Report Number: WUCS-90-19

BTC Modifications

This paper describes the modification made to the design of the Broadcast Translation Circuit based on test results from the first fabrication run. The document updates WUCS-89-52, which outlines the design of the BTC in full detail.

Figure 1. INC to BTT Upstream Data interface

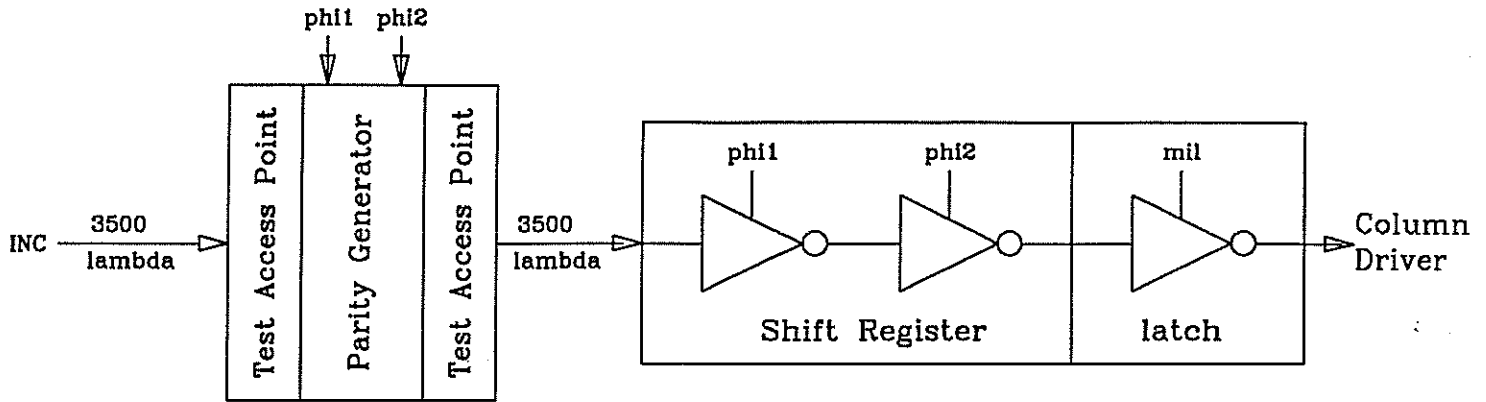
The parity generator regenerates the signal about halfway down the path. The shift registers before the latches qualified by *mil* also perform a complete regeneration. CAZM showed that a combination of two factors may have caused the failure, and both are listed below. All CAZM results are from simulation at 42MHz because no failures were observed at lower frequencies.

- The *mil* signal was asserted during $\phi 2$, i.e. while data was changing.
- The first byte of the 4-byte serial data was not latched by *pgen* due to the set-up delay from *INC* and a slow test access point design.

Figure 3. Loss of first byte of Upstream BTT data

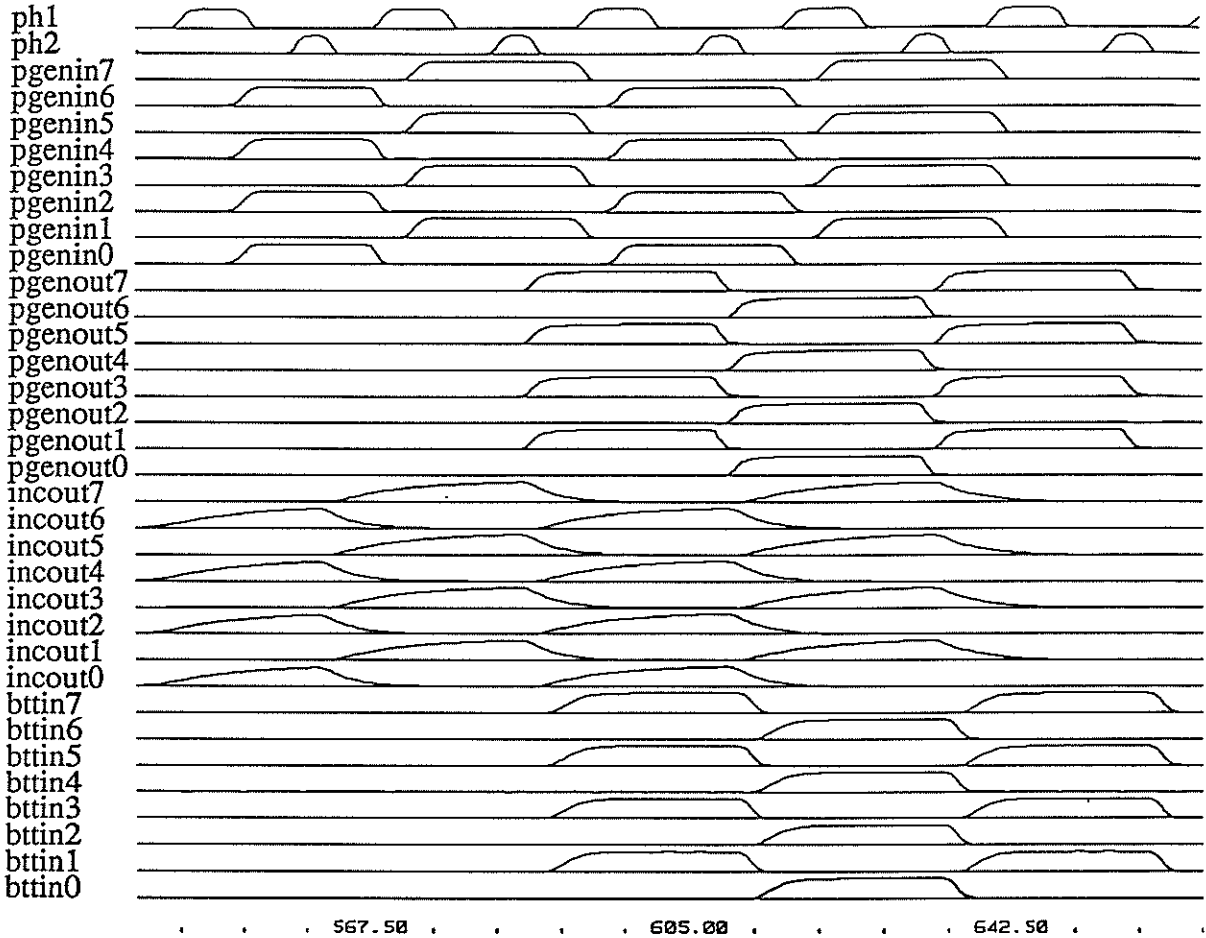
Figure 2 shows the *mil* signal with respect to the clocks. Figure 3 shows the loss of the first byte of data. Notice that the first byte of data at the input to the parity generator arrives at the trailing edge of ϕ_1 , and pgen does not register it. Both of these factors confirmed the failure observed on the device itself.

Figure 4. Block Diagram of BTT Latching Signals

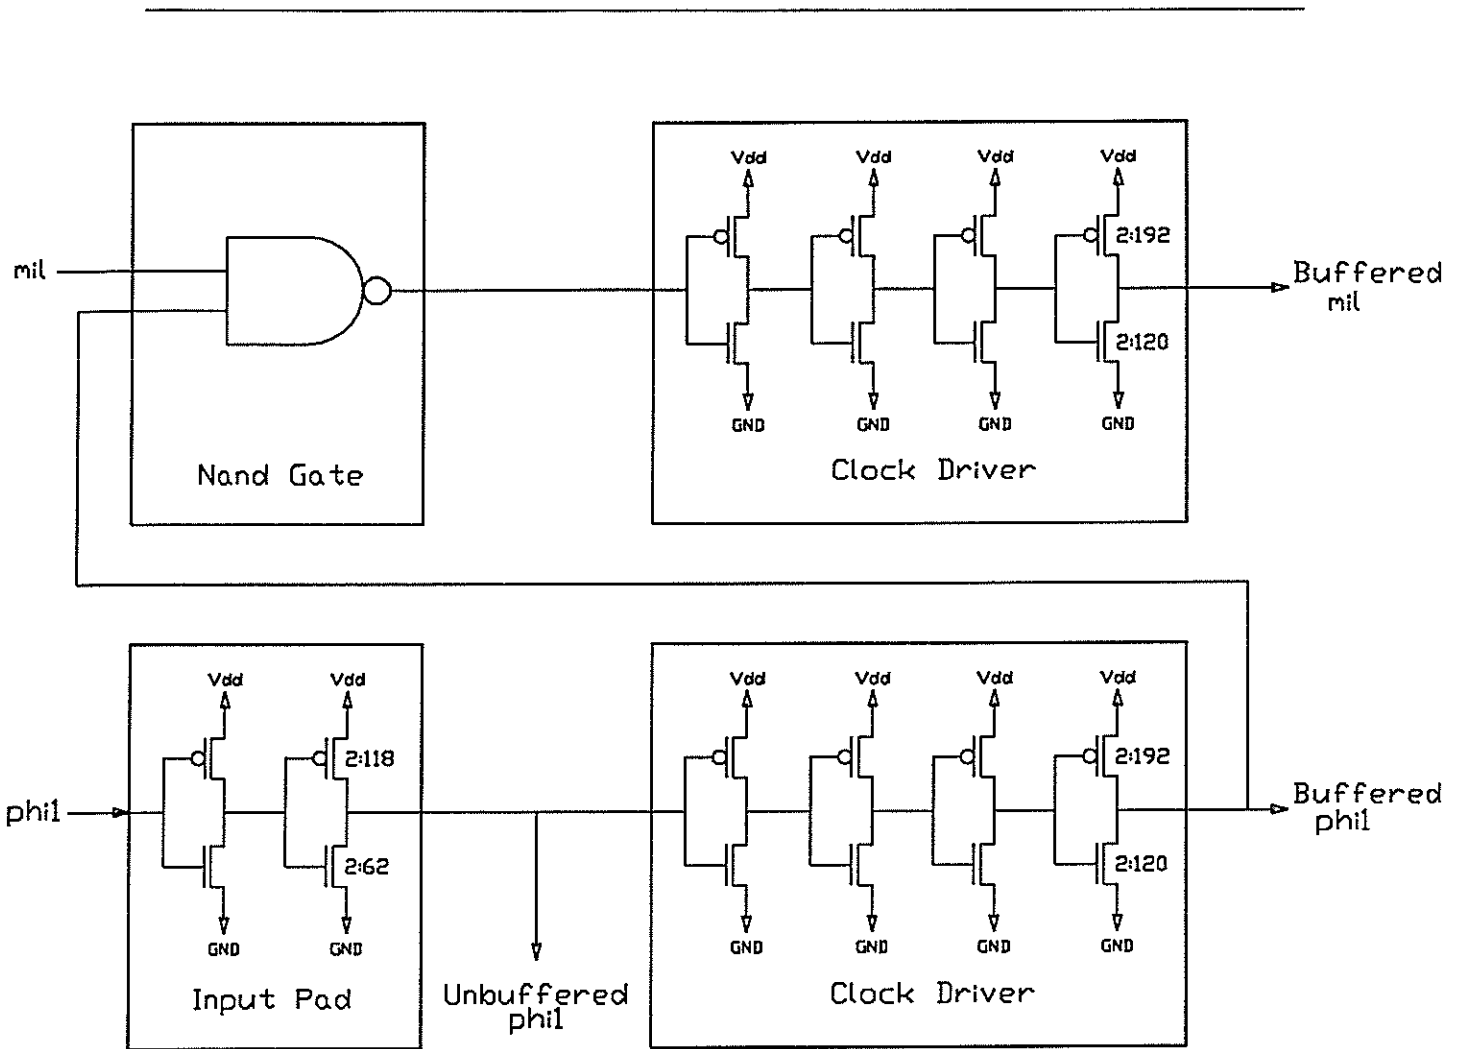
The BTT was unable to latch incoming data at high speed because the shift registers at the end of the interface regenerated the signal with respect to the clock. The *mil* latch signal was buffered by a large driver which delayed it so that it arrived while data was changing. Figure 4 shows a block diagram of how the latching signals for the BTT were set up. The most robust solution to reducing the delay experienced by signals such as *mil*, *lat* and *ld* is to qualify them with unbuffered $\phi 1$ instead of buffered $\phi 1$ because that reduces about 5 ns from the delay which satisfies the required constraints. A *CAZM* simulation showed that after the change *mil* did not overlap with the following $\phi 2$ any more at the simulation speed of 42MHz.

Figure 5. BTT Output Circuitry

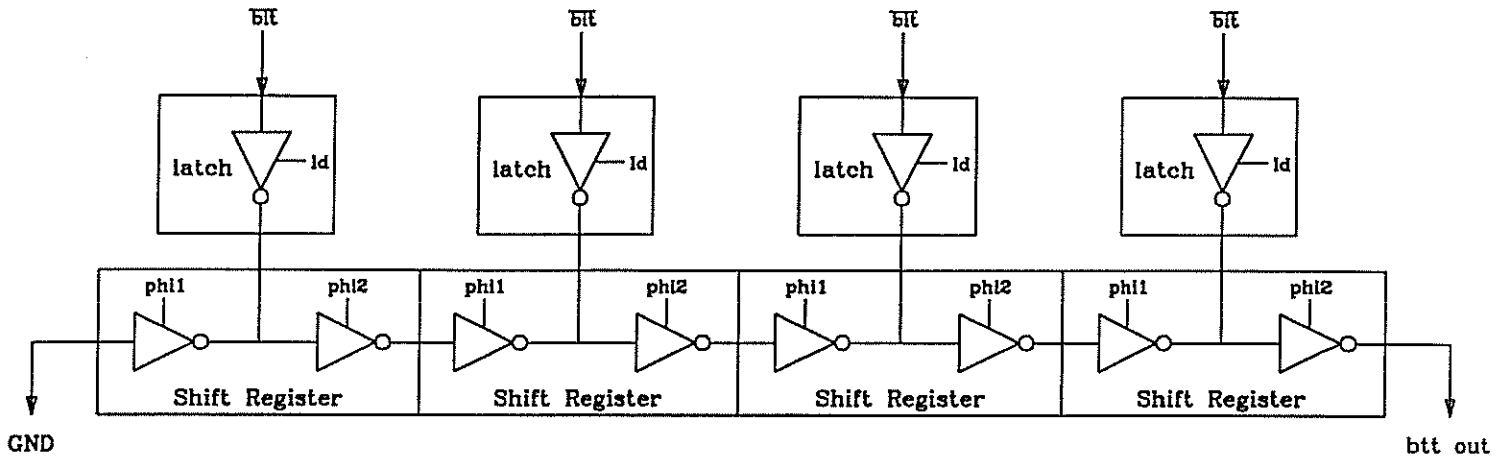
A block diagram of the downstream portion of the BTT in version 1. of the BTC appears in Figure 5.

This shows that the *PISO* shift registers are qualified by an ordinary clock. The signal *ld* is qualified by a $\phi 1$ and it appears that the output node of the downstream *PISO* latches are driven not only by the latches, but also by the preceding stage. This would cause a set of unresolved nodes. The chip did not exhibit an error because of the skew between the signals but with the modified *ld* this would cause a problem. Thus, a new signal was created called *ldop* that would be asserted during $\phi 1$ except during the clock cycle that *ld* was asserted. This signal was used in place of $\phi 1$ in the same configuration that appears in Figure 5. Figure 6 shows the relationship between *ld*, *ldop* and the clocks.

Figure 7. New Tap Design

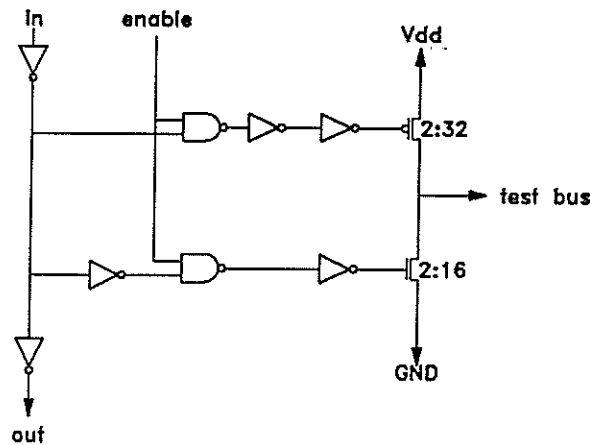
As mentioned before the original tap design was found to be inadequate. A new design was suggested that would remove the function that allowed the user to put data from the pins directly onto an internal bus. The circuitry associated with a single line passing through a test access point is shown in Figure 7. It has the nice property that all internal nodes of the tap are driven from within the tap itself.

This design change also resulted in replacement of all bidirectional pads on the chip by output pads, in removal of all the multiplexer arrangements dealing with bidirectional signals, and in removal of the direction signals controlling the three test buses.
